To: Bassett Creek Watershed Management Commission
From: Barr Engineering Co. (Karen Chandler, P.E., and Jessica Olson, P.E.)
Subject: Item 5A – Consider Approval of 60% Plans for 2025 Plymouth Creek Stream Restoration Project (CIP 2025 CR-P) – BCWMC October 16, 2025 Meeting Agenda
Date: October 9, 2025
Project: 23270051.65-6000-650

5A. Consider Approval of 60% Plans for 2025 Plymouth Creek Stream Restoration Project, Plymouth (CIP 2025 CR-P)

Basis for Commission Review: 60% Plans Review

GENERAL
COMPARISON BETWEEN FEASIBILITY PROPOSED WORK
AND 60% DESIGN PROPOSED WORK
STATION 0+00 TO 11+50

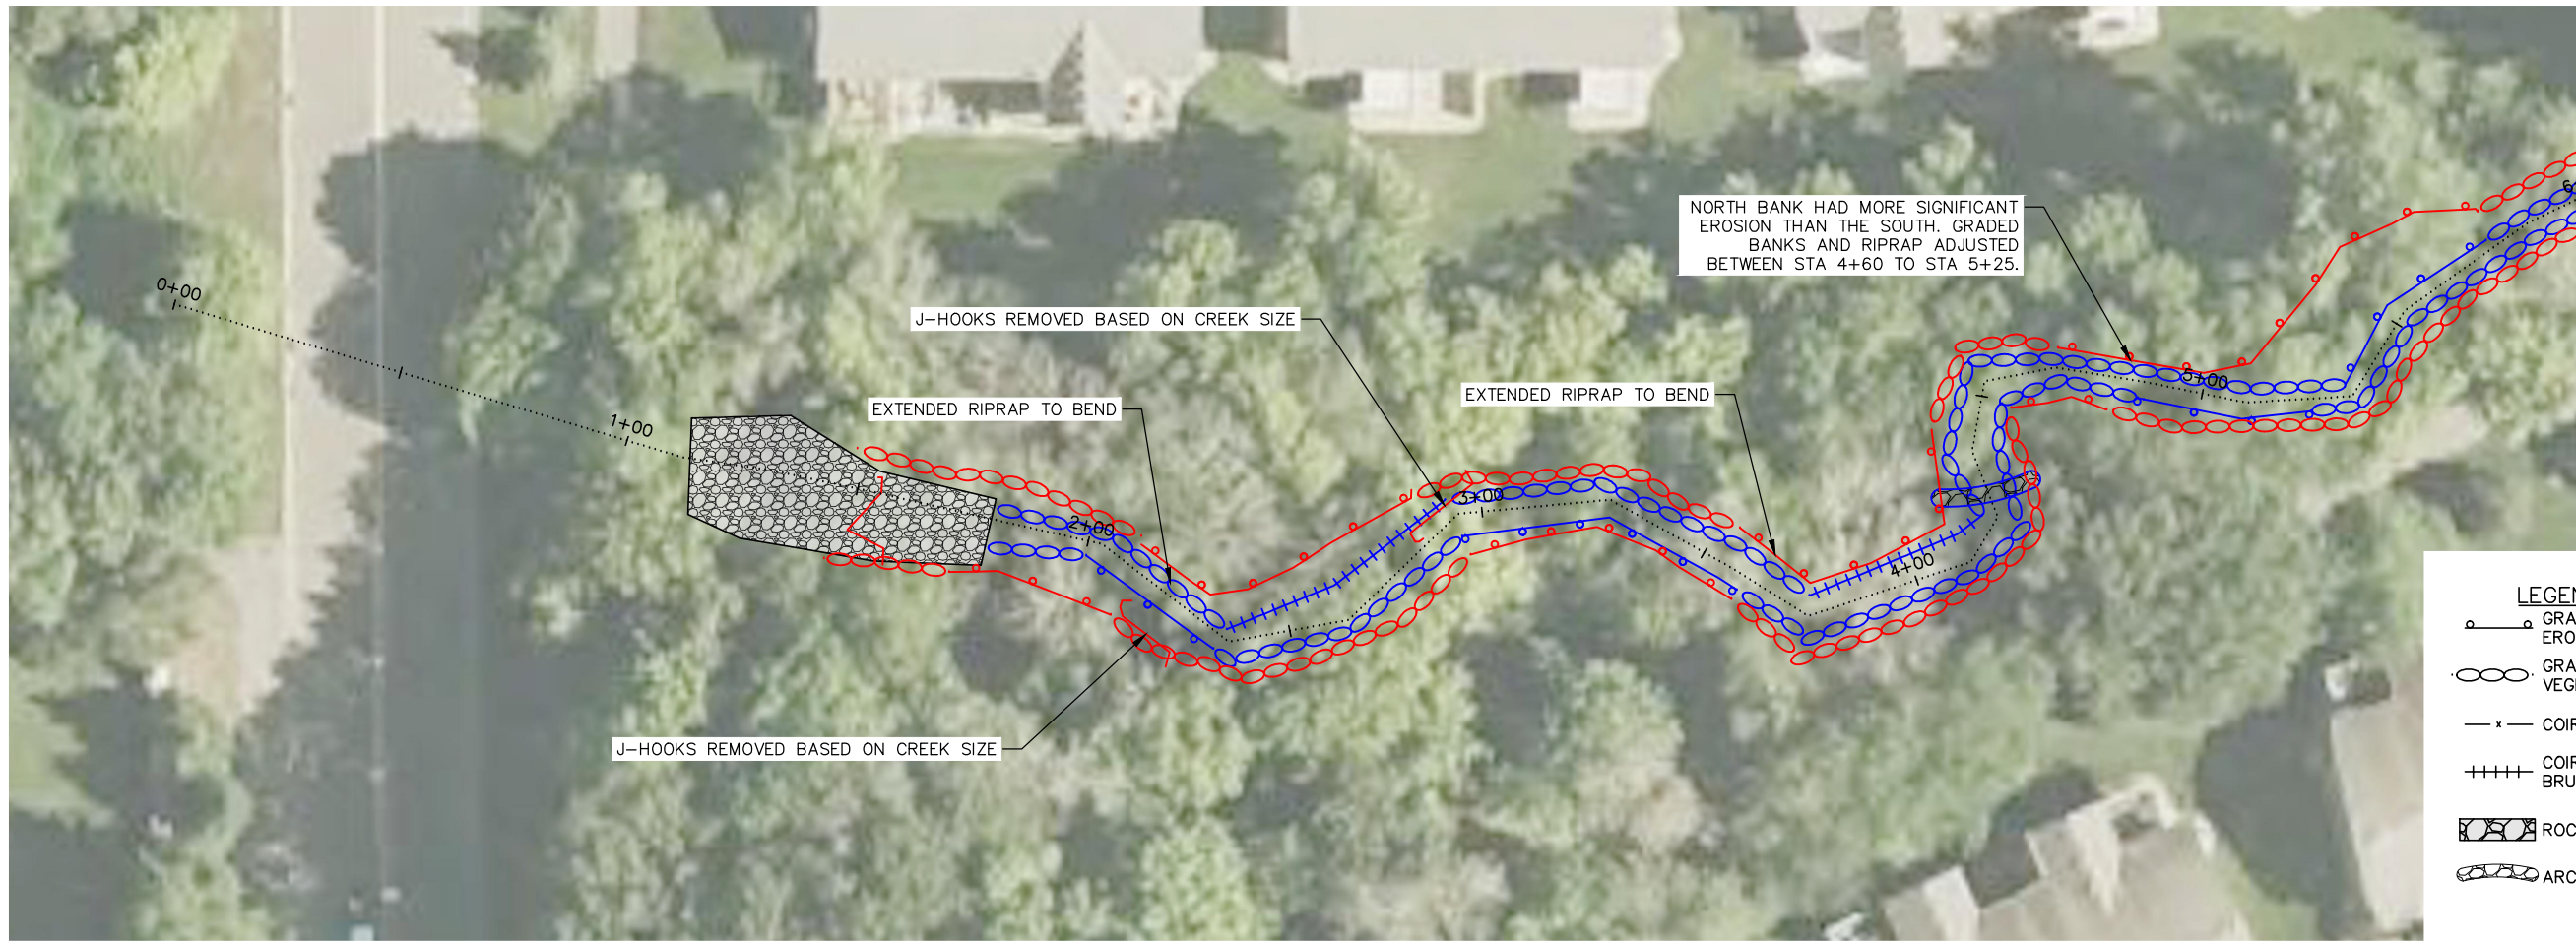
- 17) Consider replacing the vegetated riprap between Sta. 10+00 and 14+00 with coir log and/or brush mattress. These areas have lower velocities and the coir/brush mattress will provide better habitat as there is potential for the soil over the riprap below the normal water level to be washed away

GENERAL
COMPARISON BETWEEN FEASIBILITY PROPOSED WORK
AND 60% DESIGN PROPOSED WORK
STATION 11+50 TO 21+50

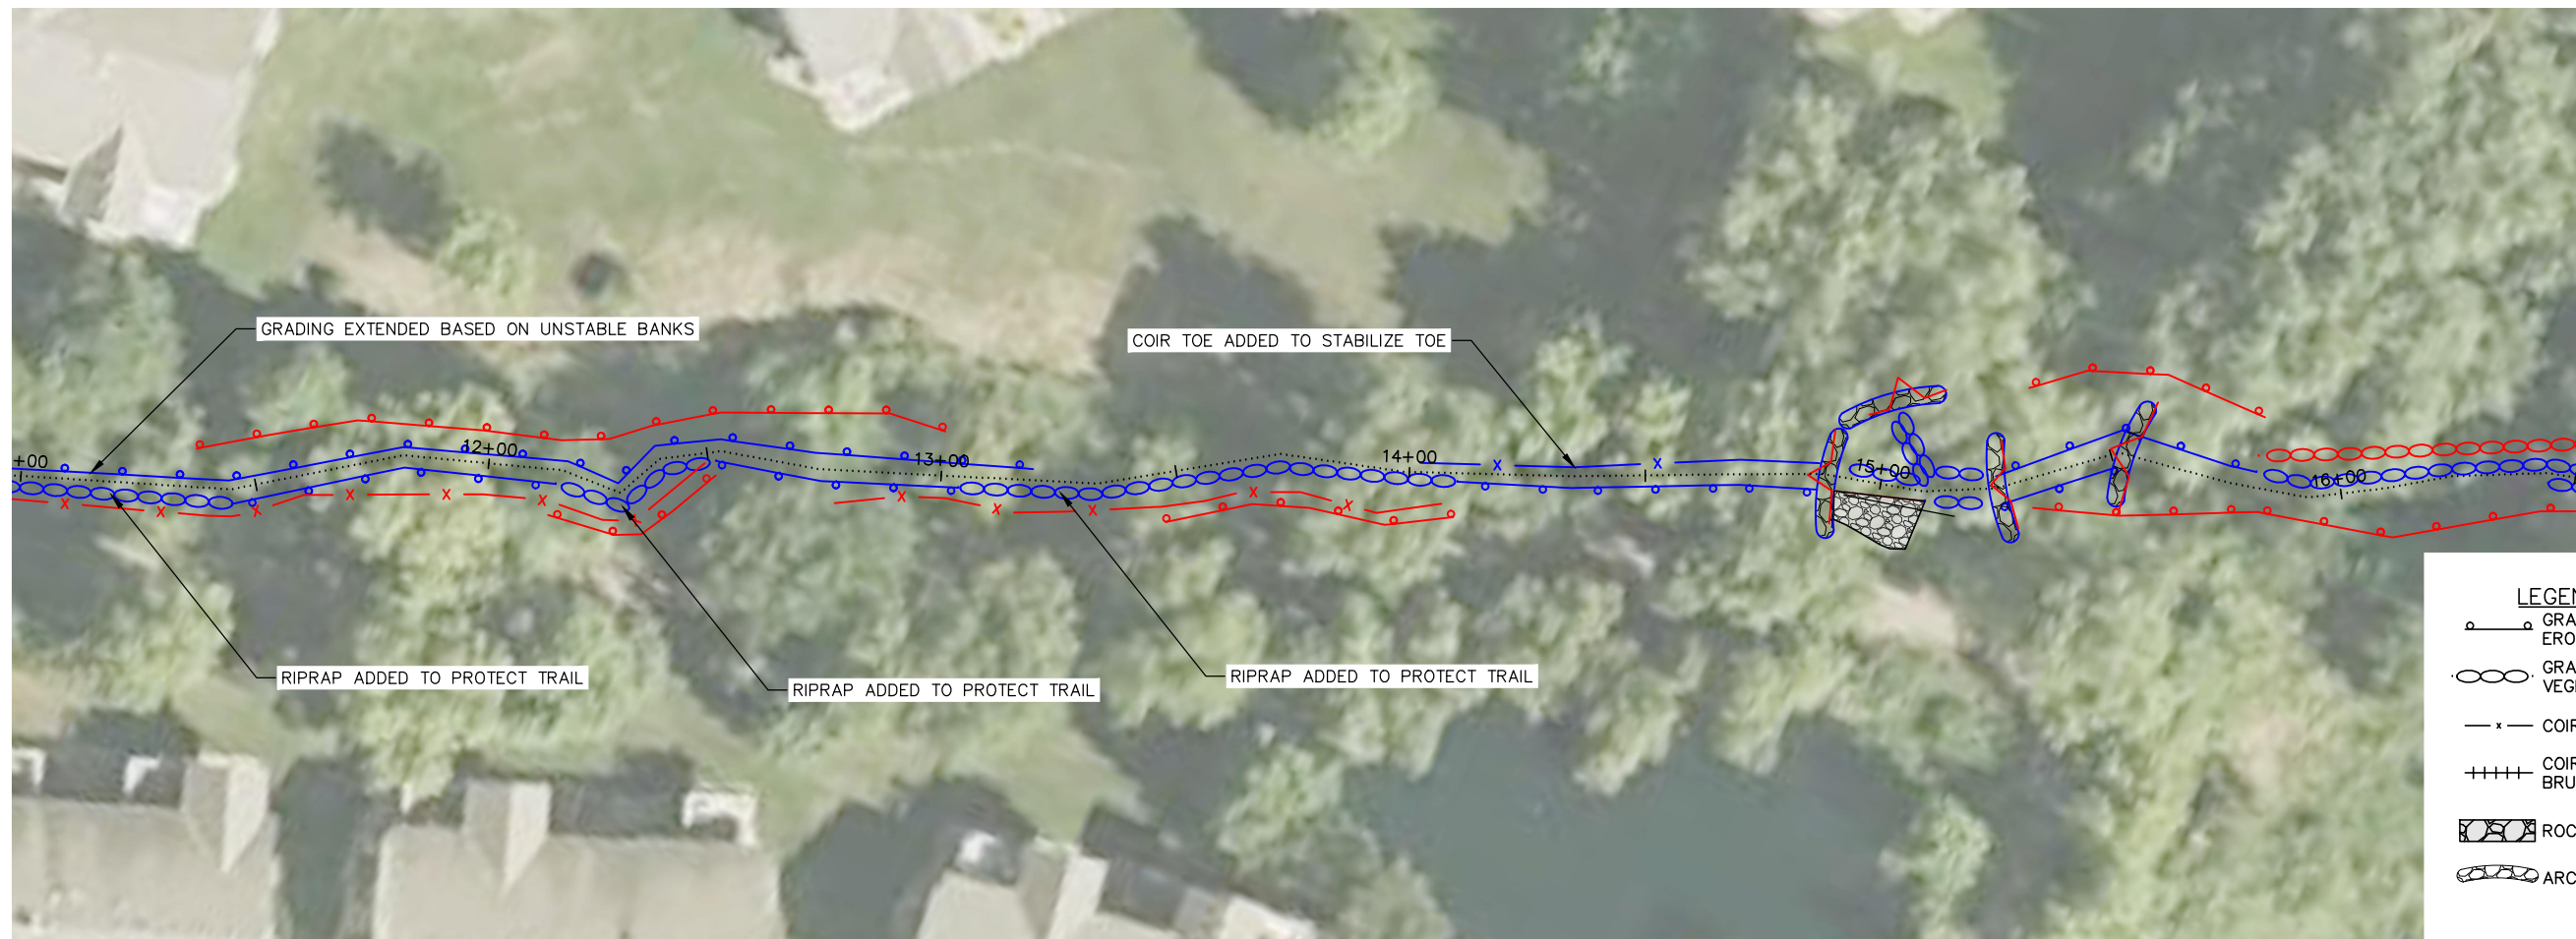
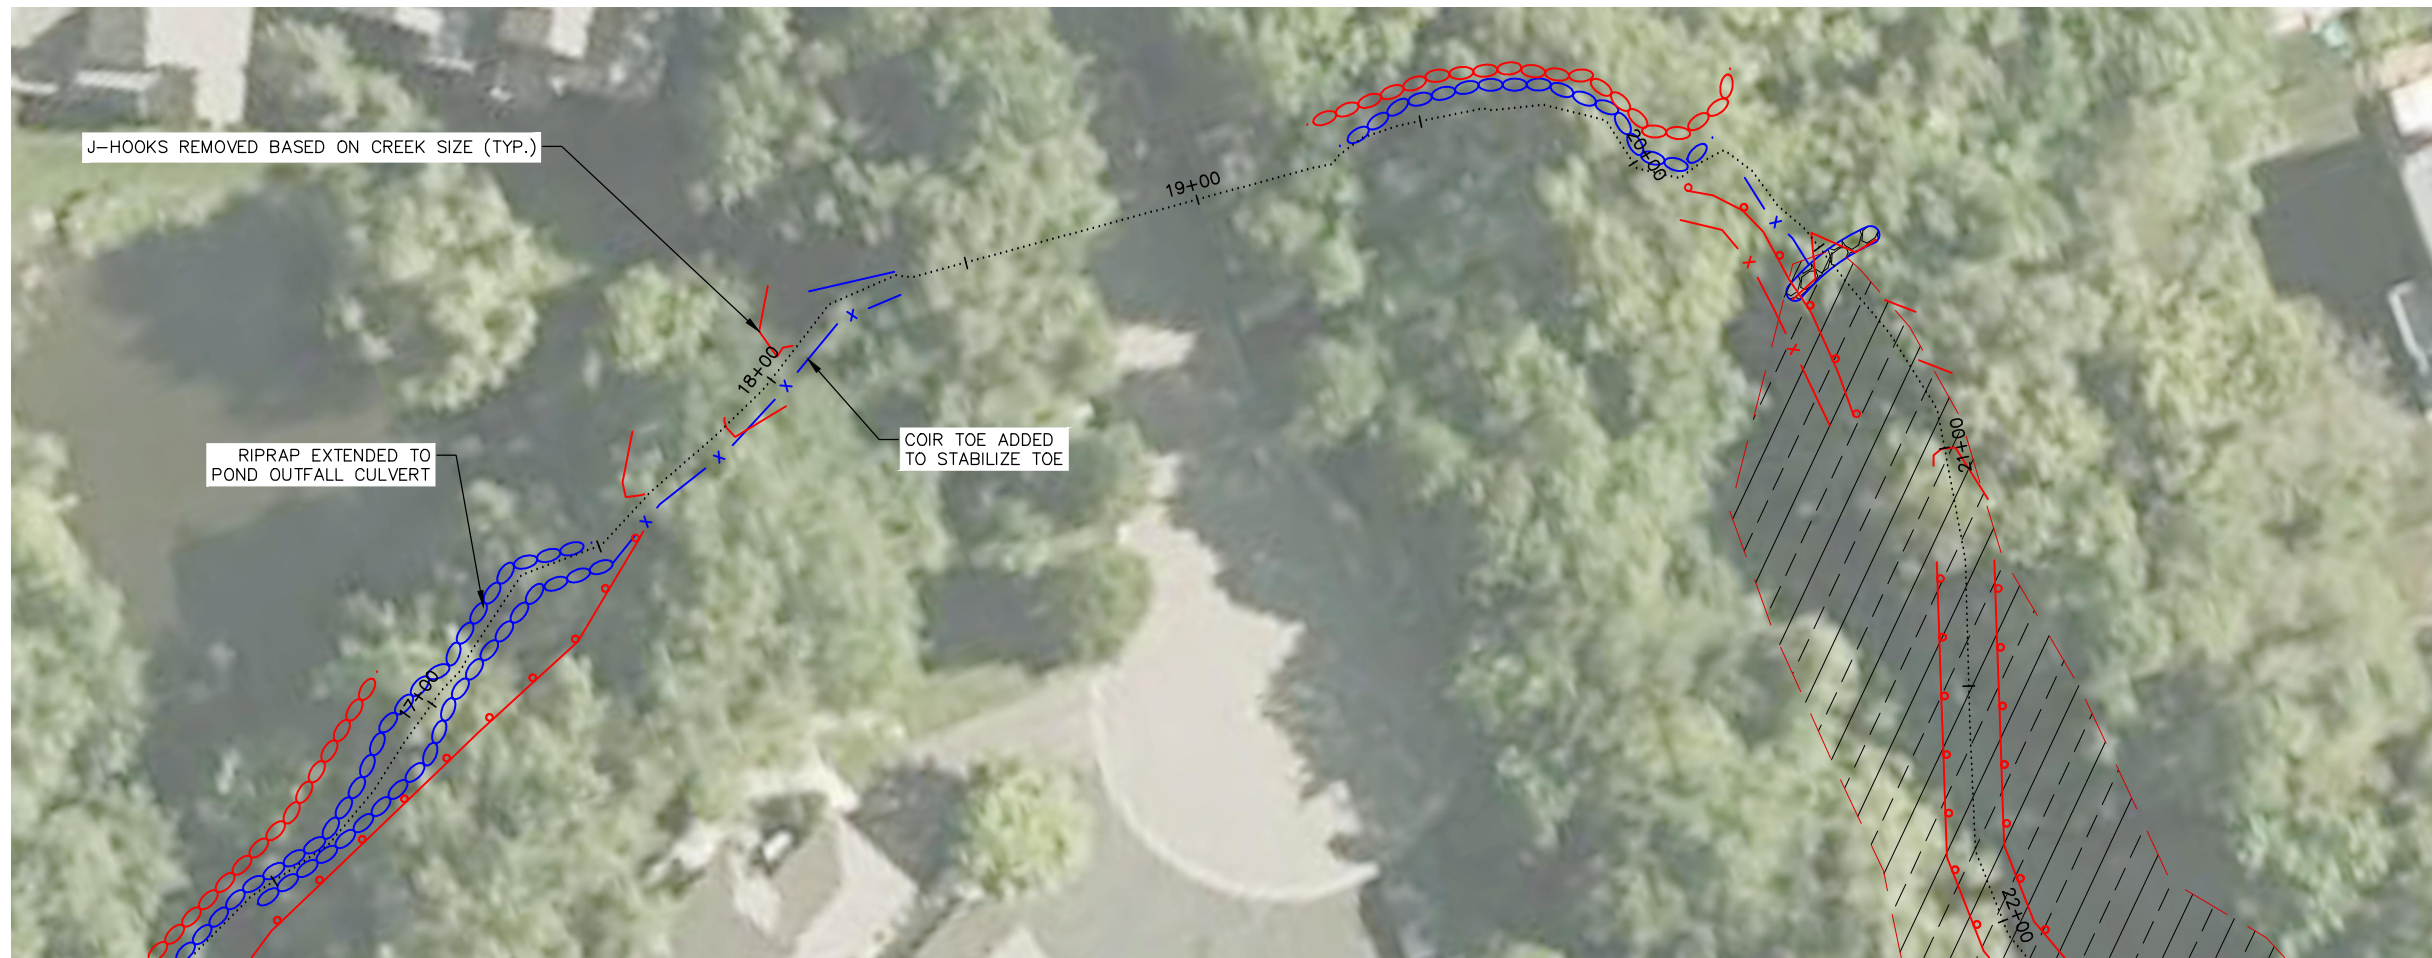
- 18) Why is vegetated riprap proposed around Sta. 17+00 but not at Sta. 18+20, where the velocities are noted as being above 4 feet per second? Should vegetated riprap be included at Sta. 18+20? Consider using coir toe if velocities are lower than 4 feet per second.

- 20) The feasibility study included cross vanes in the drainage channel upstream of Plymouth Creek near Sta. 20+20. Please clarify if work will be proposed in this channel to stabilize the channel invert.
